Technical Memorandum

To: Bill Johnson
From: John Swenson and Jeré Mohr
Subject: Response to questions on saline groundwater
Date: September 7, 2012
Project: NorthMet SDEIS – 23690862.00 042 002
c: Jim Scott, PolyMet

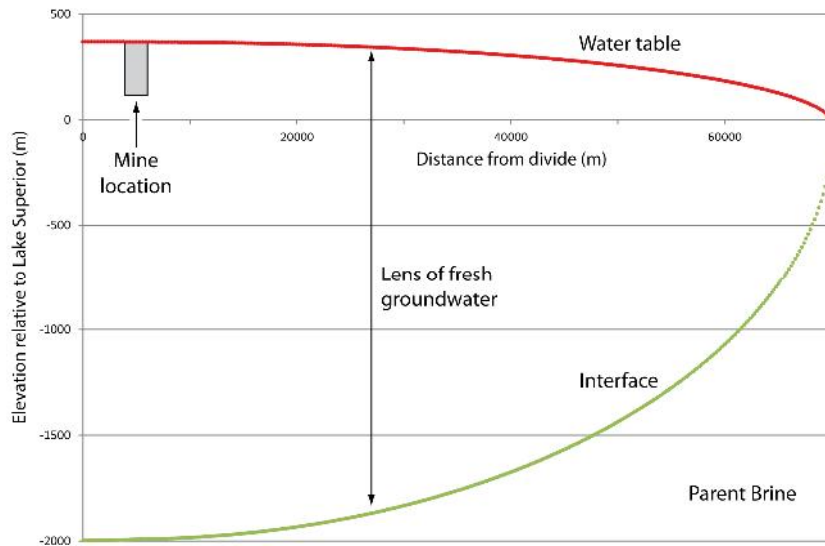
The *impact* of brackish water interception by PolyMet is reduced based upon my understanding that there is no planned discharge from the active pit(s). It is also possible that the volume of brackish groundwater is limited and will be exhausted by the time of filling in the West Pit. However, if elevated salinity of the water is sustained, it may still be important in considering:

1. Water quality of the West Pit as part of the reclamation after it is allowed to fill
 - a. it could impact the biota that would become established in the West Pit and/ or
 - b. have potential downstream effects as the pit converts to an open system.
2. Though less probable, higher salinity levels could possibly affect their internal processing reactions (may mean some additional processing or make-up water to dilute)

Based upon this understanding, it is worth considering testing the groundwater from the existing boreholes for chloride, salinity or total dissolved solids. Although there may be no *ideal* way to test borehole water for salinity to full depth, testing the upper 500 feet +/- may be possible with a submersible

Available regional and site data suggest that the NorthMet pits will not directly intersect groundwater with elevated chloride concentrations because it is located at elevations below the currently-planned mine depths. However, as described in the attached document, there is a small potential that pit dewatering could cause sufficient perturbation to the underlying salinity structure to allow brackish groundwater to migrate upward and discharge to the pit while it is being dewatered.

Fundamentally, the driving mechanism for potential discharge of brackish water to the mine pit is dewatering of the pit itself, which, from the perspective of the regional groundwater flow system, generates a region of anomalously low hydraulic head. It follows that abandonment and subsequent flooding of the mine act to shut off this driving mechanism and return the flow system to its pre-mine configuration. In essence, as the mine pit floods and the hydraulic-head anomaly dissipates, the salinity structure beneath the mine will relax to its pre-mining, equilibrium configuration. Therefore, any discharge of brackish groundwater to the pits that does occur would be expected during operations or in the early stages of pit flooding, when groundwater pumped from the pits will be routed to the Mine Site wastewater treatment facility. In addition, if brackish water does discharge to the pits, it would likely represent a very small proportion of the overall water inflow to the pit.

Under the above assumptions, the flow model has an analytical solution for the water-table elevation and corresponding interface location (Figure 1). At the regional scale of the cross section in Figure 1, the impact of the mine dewatering is difficult to discern. Figure 2 shows the difference in water-table and interface elevation for pre-mine and dewatered-mine conditions; in essence, Figure 2 shows the 'drawdown' of the water table due to dewatering the mine and the associated 'intrusion' (vertical translation) of the interface. For the parameter values listed above, dewatering the mine yields approximately 20 meters of drawdown in the water table at the mine pit (a value consistent with that of the high resolution MODFLOW model constructed by Barr), which by isostasy generates approximately 110 meters of interface translation. In the context of this idealized model, in which the parent brine is depressed more than two kilometers below the mine site, dewatering the mine pit will not result in an influx of the parent brine to the pit. In the natural system, however, the interface most likely has the form of a mixing zone of poorly constrained thickness. If translation of the mixing zone in response to mine dewatering mirrors the intrusion of the interface in the idealized model, then any brackish groundwater within approximately 100 meters of the pit floor has the potential to discharge to the mine. For reference, brackish groundwater was observed at the AMAX/Minnamax site at depths that would correspond to 120 meters and 180 meters *below* the proposed maximum depth of the NorthMet mine pits.
